**City of Sonoma
Design Review and Historic
Preservation Commission
AGENDA**

**Regular Meeting of September 20, 2016 - 6:30 P.M.
Community Meeting Room, 177 First Street West
Sonoma, CA 95476**

City of Sonoma
Design Review and Historic
Preservation Commission
Agenda Item Summary

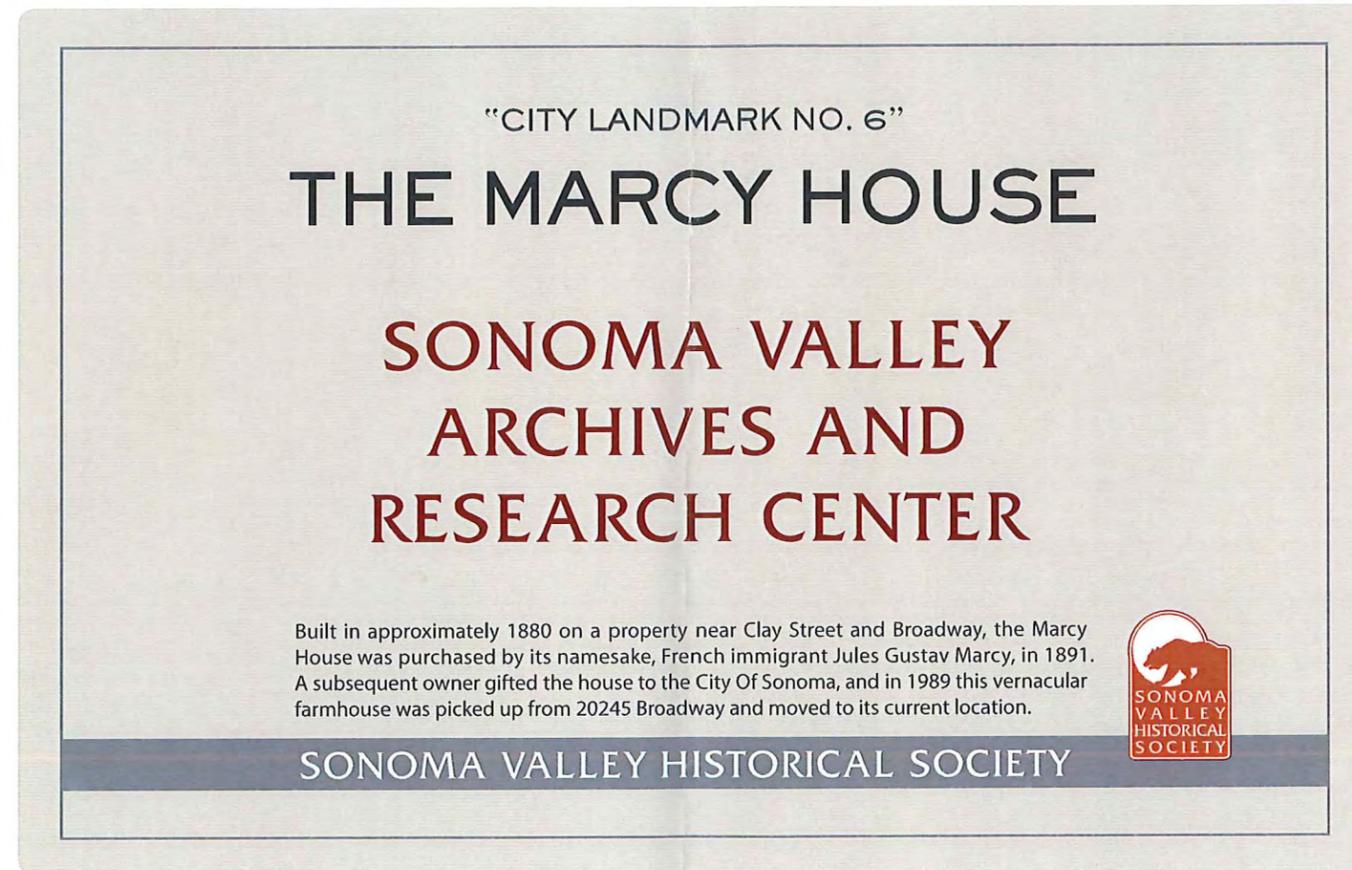
The building was not named Marcy House when it was purchased and the paragraph should be revised to reflect that information.

Will the two flag poles be removed?

- The flag poles will remain. The flagpoles are further from the setback required as per code for the sign and will not be moved.

L-1.0

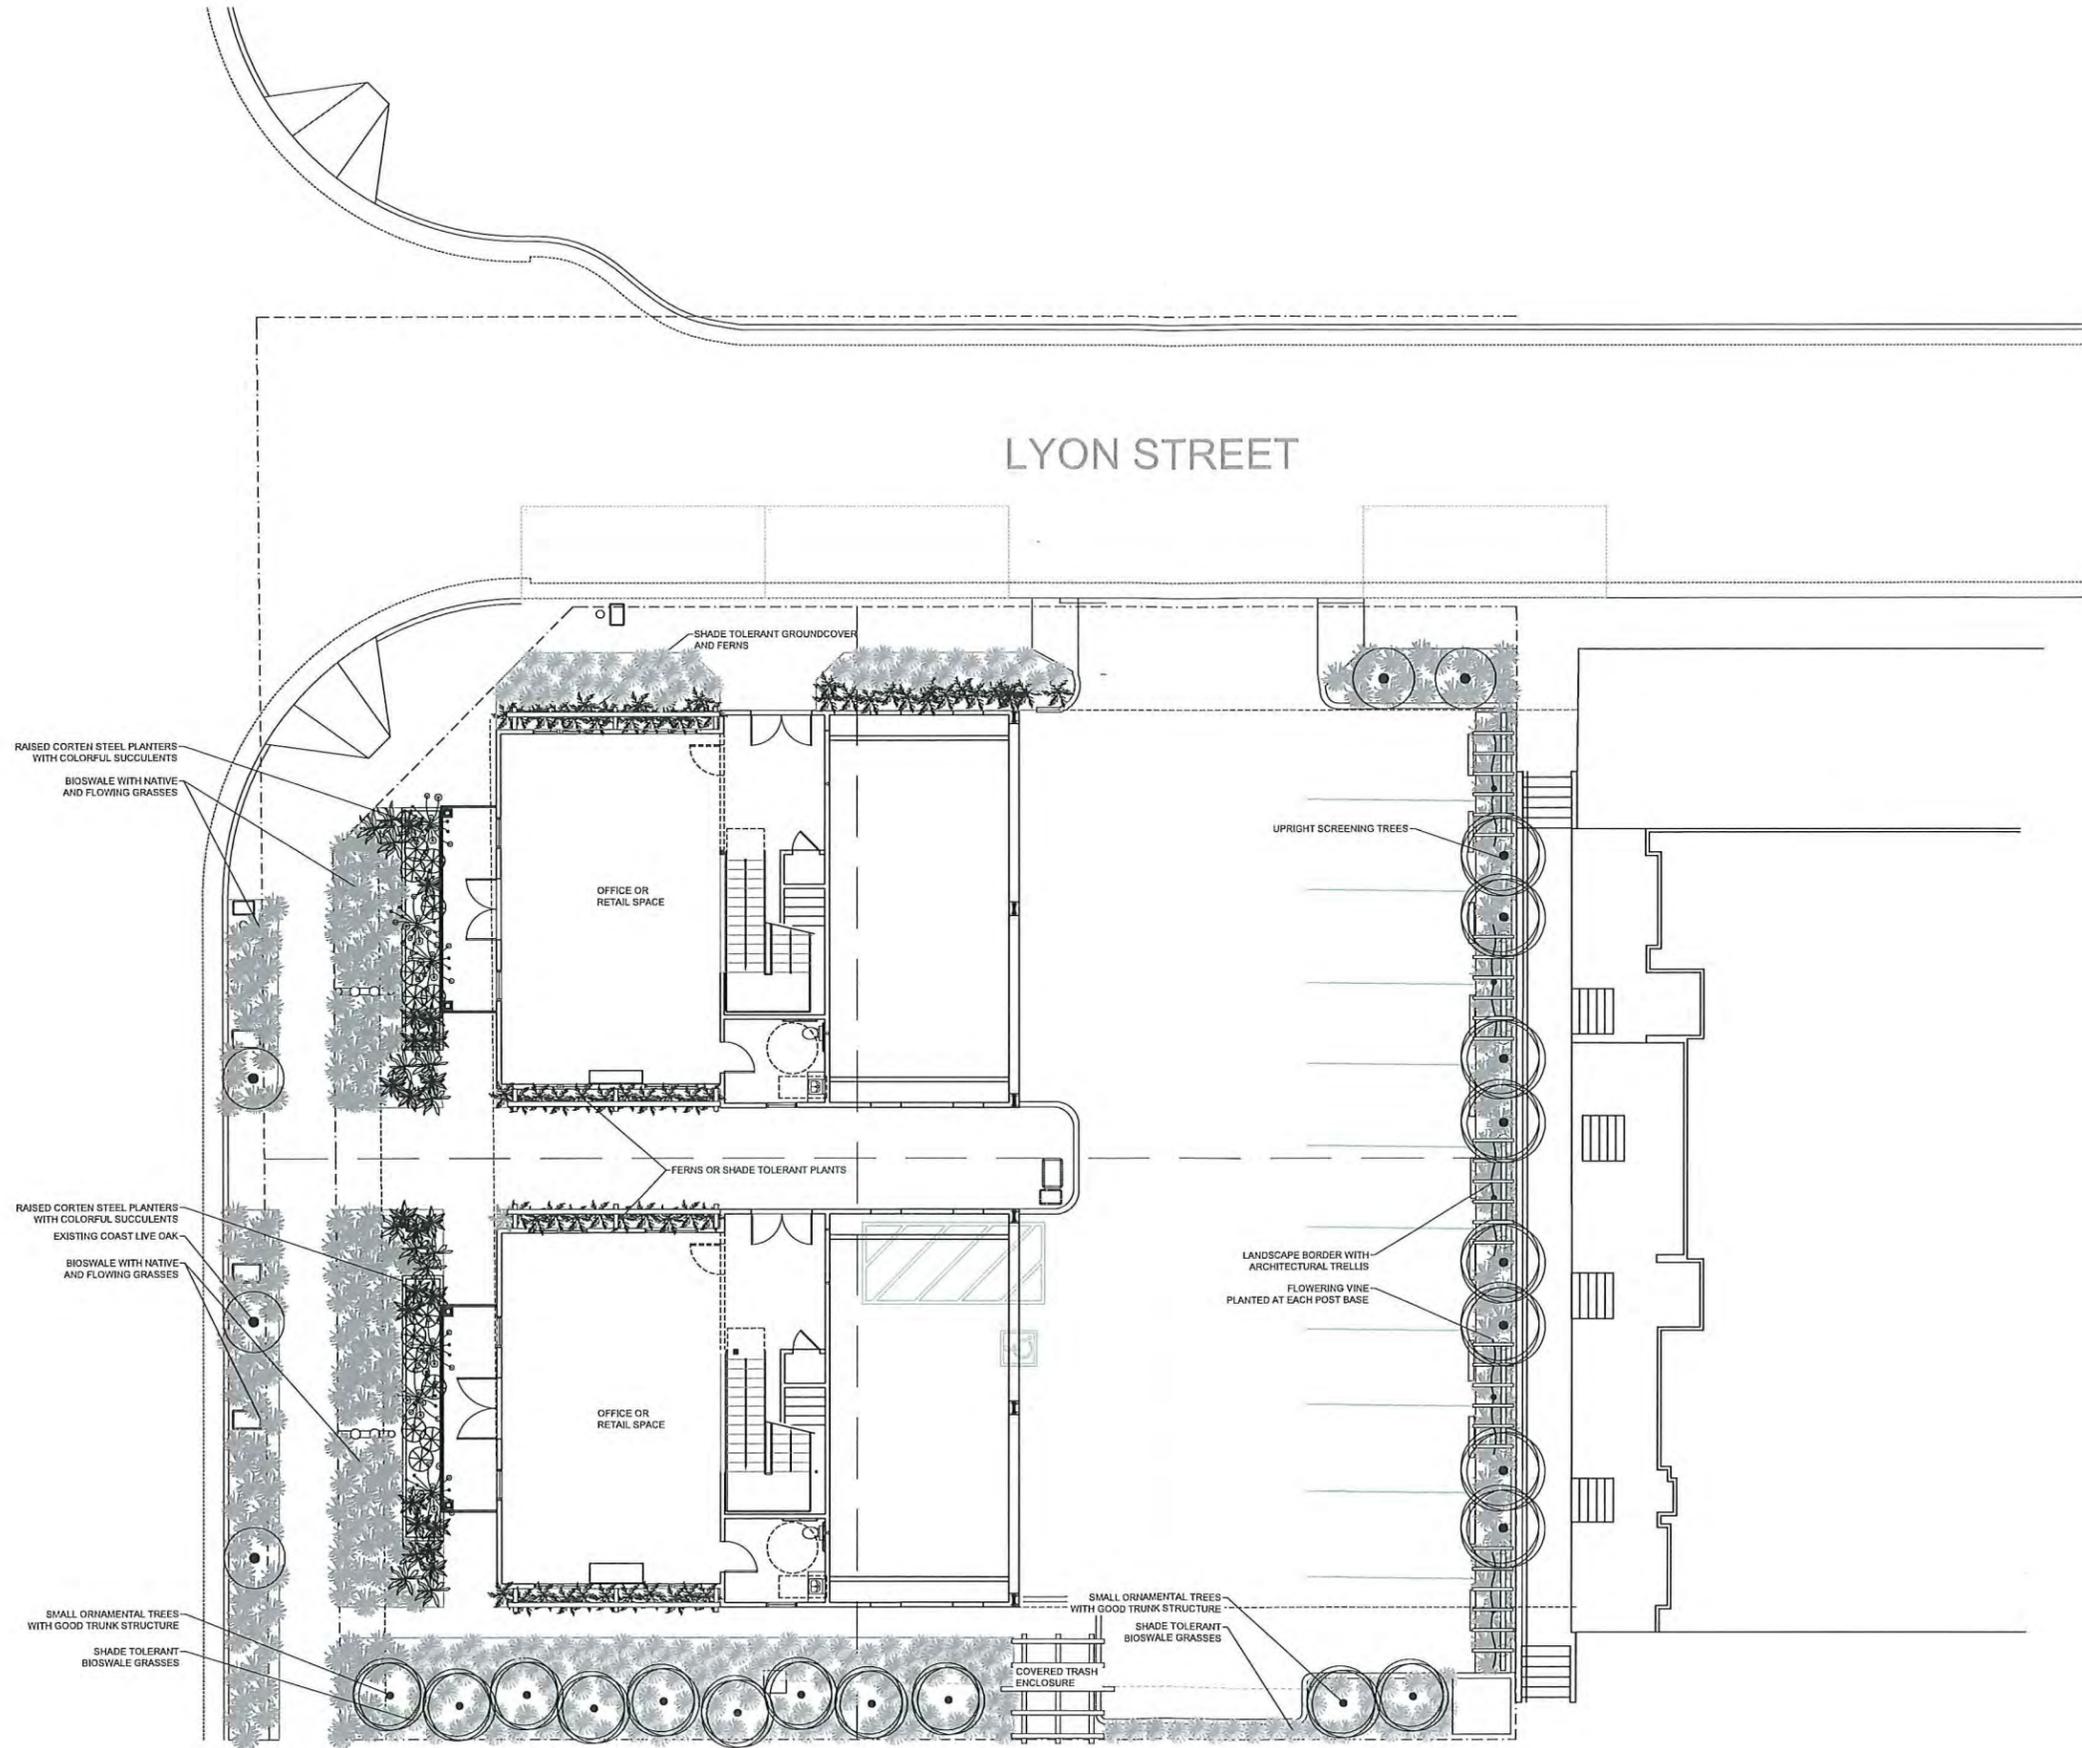
Landscape Plan: Landscape plans have been provided (Sheets L-1.0, L-1.1, L-2.0, and L-3.0) including a comprehensive plant list identifying trees, grasses, ferns, vines/groundcovers, and succulents.

Tree Plantings: The landscape plan indicates that nineteen trees would be planted on the site [eleven eastern redbud (24-inch box size) and eight Callery pear (15-gallon box size box size)] supplemented with grasses, ferns, vines/groundcover, and succulents.

- a. Trees removed from the project site shall be replaced on-site at a ratio of 2:1, with a minimum box size of 24 inches.
- b. The fruiting olive trees shall be relocated from the site and replaced in quantity on-site with non-fruiting olives.
- c. The developer shall adhere to the tree protection measures and pruning guidelines presented in the arborist report.
- d. Four street trees, with a minimum box size of 48 inches, shall be planted along the Sonoma Highway frontage.
- e. The 15-in DBH coast live oak located in the center of the site (identified as tree No. 36 in the arborist report) shall be preserved if feasible.
